1.	Release Date: 02/11/2020						
2.	Service Letter No.: SL47 65-17190						
3.	Subject: LSP Cable Installation						
4.	Part/Assembly No.: 65-17190						
5.	Float Model Affected: 6650 and 6750						
6.	Compliance: Mandatory Recommended	Optional					
7.	Approval: All information provided is in accordance with approved data.						
	Corrective Action: Non-required.						
9.	Time Required: Approximately 1 hour.						
10.	Payments: Credit to Customer Under Warranty	Customer Pays

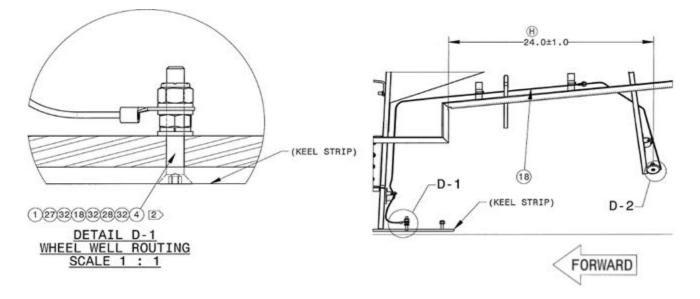
The current lightning strike protection (LSP) configuration is connected thorough use of keel installation fastener at Float STA. -4.63 which falls inside the Main landing Fear (MLG) box. That was in turn routed aft to the next fastener for the aft keel strip.

Previous Configuration MLG Location

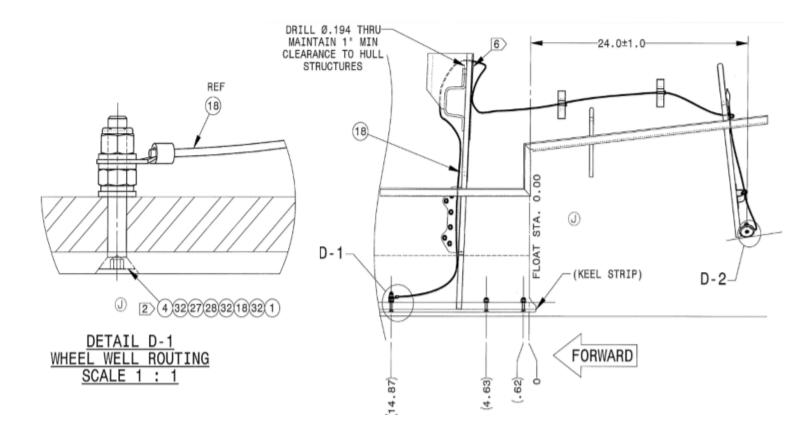
The purpose of this service letter is to explain the move of the LSP connection between fore and aft keel strips at the MLG so that it does not penetrate the gear box, and is therefore, higher in the waterline. This will eliminate sealing issues sometimes encountered where the wire passes through the box below the waterline. The LSP wire connection at the nose gear moved outboard for better access and increased distance from hydraulics.

The wire connection and hardware were moved to the next forward keel strip installation hole, allowing the LSP wire to only penetrate the bulkhead, which is inside the sealed compartment, and routed to the aft termination (unchanged).

Sheet 1

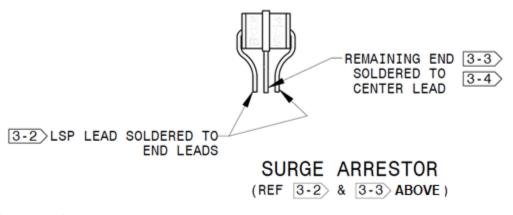
Note 5 changed to:

5. USE TECHFLEX™ "FLEXO FR" EXPANDABLE SLEEVING TO PREVENT CHAFING OF CABLE AGAINST SURFACES WHERE NECESSARY. SECURE ENDS OF SLEEVING WITH MS3367-4-9 TIE WRAPS OR HEAT SHRINK SLEEVING, SUCH AS MS23053/4-302 OR M23053/5-305. M23053 SLEEVING SHALL BE FLEXIBLE, CLASS 3, COLORATION OPTIONAL, SIZE AS REQUIRED.
